465-2025 ADDENDUM 2

WINNPEG TRANSIT – FORT ROUGE FACILITY

PROPOSED LOT GRADING PLAN

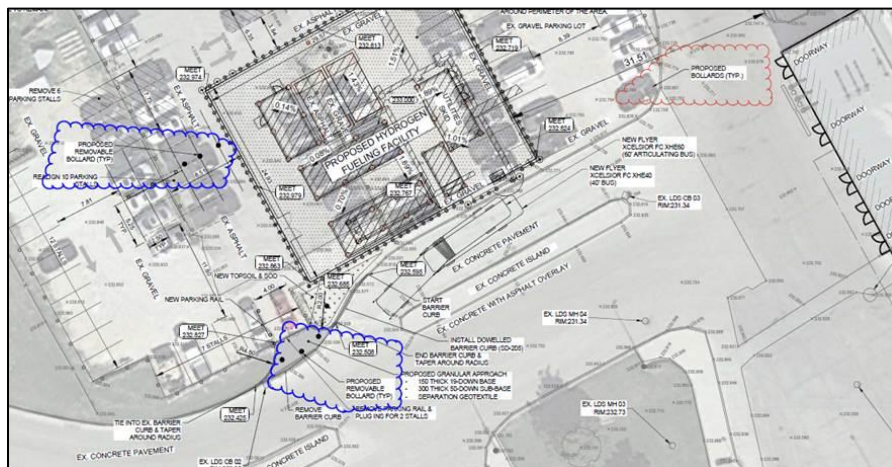
Q2: Clouded in blue below, are the removable bollards detail the same as shown on the detail G of drawing S0006?

Clouded in red below, it shows “*PROPOSE BOLLARD (TYP)*” but is not pointed on any bollard. Please advise for us to know the quantity and if the detail would be the same as shown on detail F of drawing S0006?

A2: The six (6) removable bollards shown on Drawing C04 shall match Detail G on Drawing S06.

The bollard label "*PROPOSED BOLLARDS (TYP)*" on Drawing C04 is meant to be pointing to the four (4) bollards around the new fire hydrant and should match Detail F on Drawing S06.
